CHANGE ORDER REQUEST
 COR No: 53.00

Re: 3405 – Scotts Valley Middle School Modernization
 Subject: Bulletin 31 – Landscaping and Irrigation Changes

BULLETIN - DSA

ISSUE DATE	January 4, 2018	BULLETIN NO	031
PROJECT NAME	Scotts Valley Middle School	DSA FILE NO	44-43
CAW PROJECT NO.	14033	APPLICATION NO	116046
ISSUED TO	TJ Gunter C. Overaa & Co. 2380 Gume Dr, Suite A San Jose, CA 95131	Reference	RFI 157.1
ISSUED BY	Monique Wood		
CC:

L3.02A

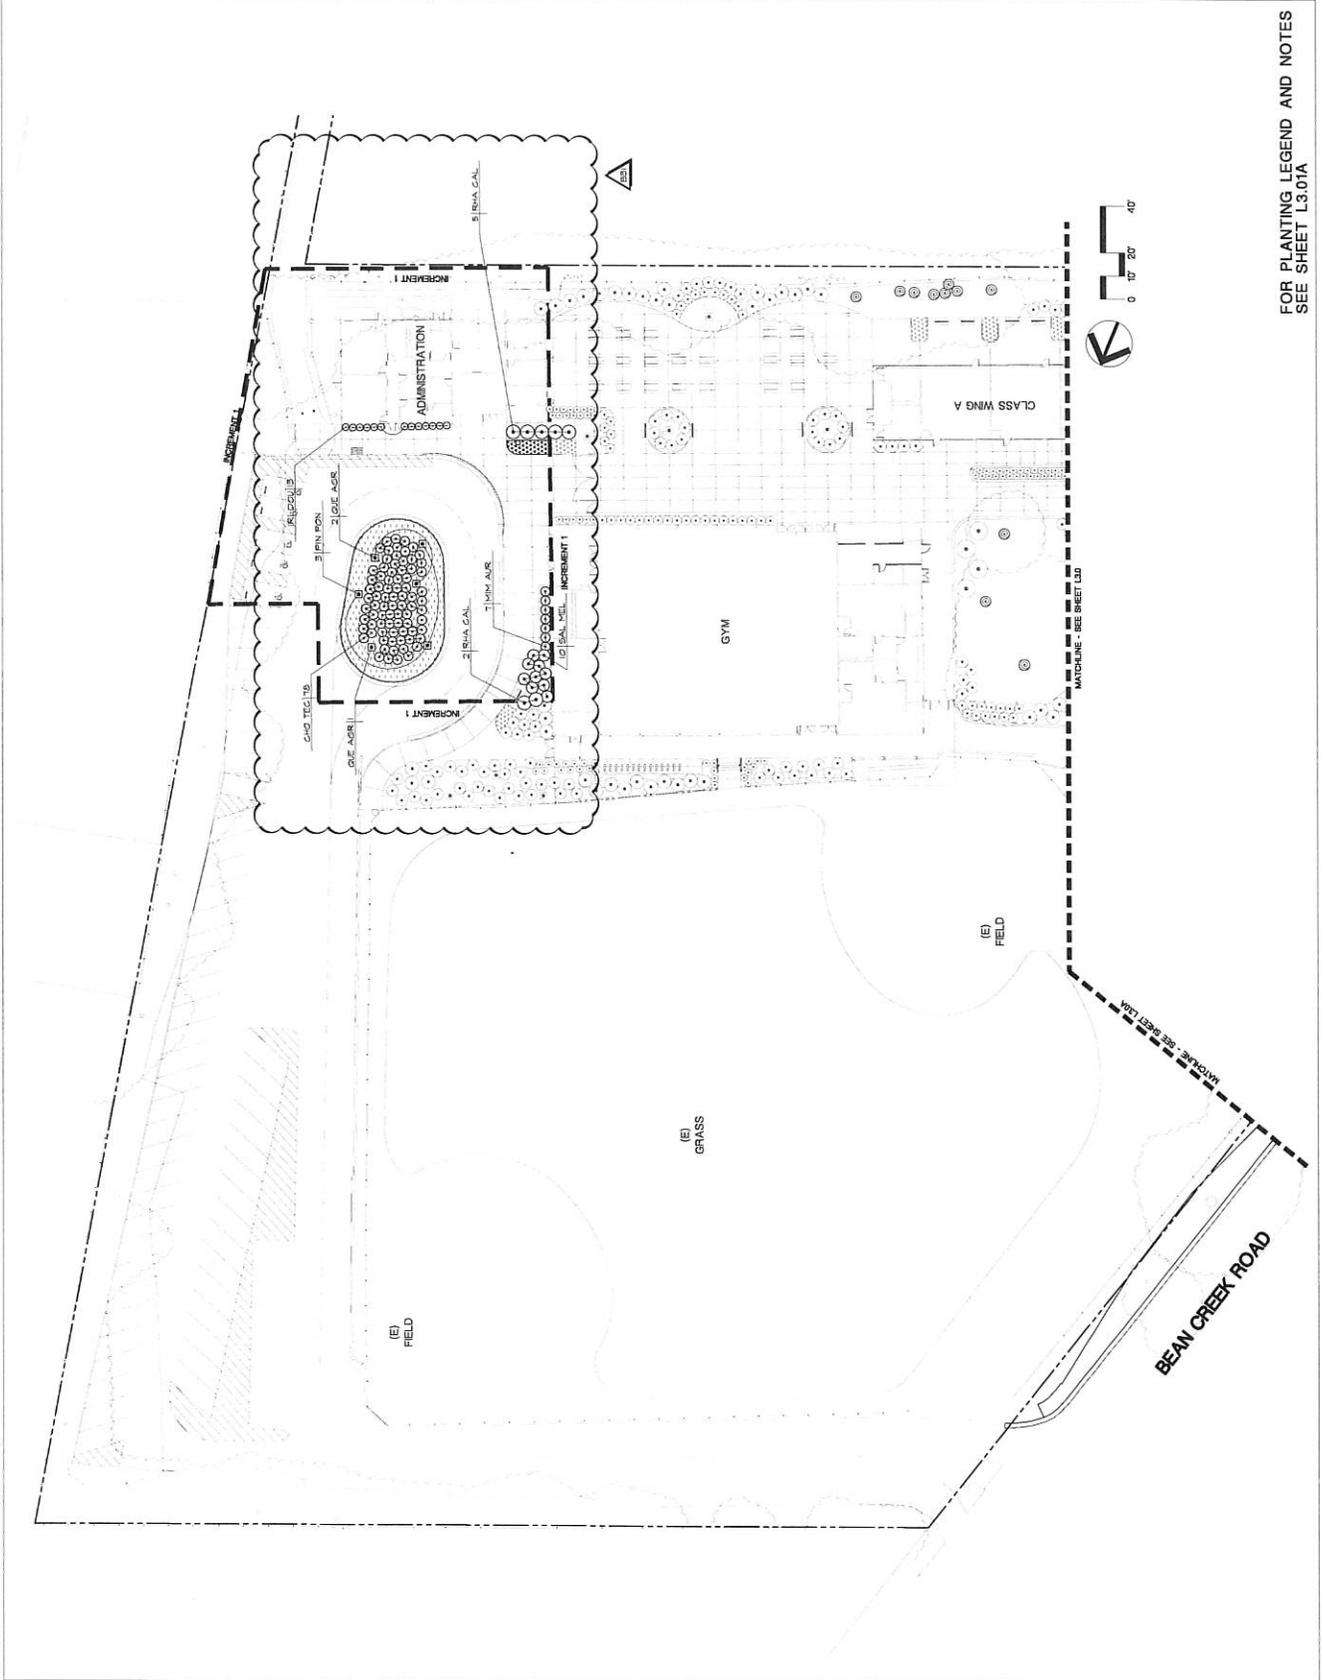
1	<p>Adjustment to <u>irrigation</u> plan and schedule sheets L201A, L202A, L203A, L201B, L202B and L203B to represent the following changes in irrigation layout and materials:</p> <ul style="list-style-type: none"> • Original valve 13 and 22 for tree bubblers have been removed. Other valve numbers are adjusted accordingly. • All the irrigation zone precipitation rates have been updated. • Add 2 tree bubblers in front of MPR Building for 2 new <i>Quercus agrifolia</i>. • 54 shrub bubblers have been added for new shrubs. • Water budget calculation and irrigation schedule have been adjusted according to new valve numbering and gpm.
2	<p>Adjustment to <u>planting</u> plan sheets L301A, L302A, L301B and L302B to represent the following changes in planting materials:</p> <ul style="list-style-type: none"> • Replace <i>Arbutus unedo</i> with <i>Hetermeles arbutifolia</i> • Replace <i>Cercis occidentalis</i> with <i>Pinus ponderosa</i> at turnaround bio-retention area. Remove <i>Cercis occidentalis</i> elsewhere. • Replace <i>Arctostaphylos densiflora</i> 'Howard McMinn' with <i>Dendromecon rigida</i> 'Harfordii' • Replace <i>Artemisia</i> 'Powis Castle' with <i>Salvia mellifera</i> • Replace <i>Ceanothus</i> 'Julia Phelps' with <i>Rhamnus californica</i> • Replace <i>Ribes viburnifolium</i> with <i>Salvia mellifera</i> • Replace <i>Zauschneria californica</i> with <i>Mimulus aurantiacus</i> • Replace <i>Festuca californica</i> with <i>Festuca rubra</i> • Add 2 <i>Quercus agrifolia</i> in front of MPR Building where existing oak tree was removed • Due to the spacing changes for substituted shrubs, 54 additional shrubs have been added
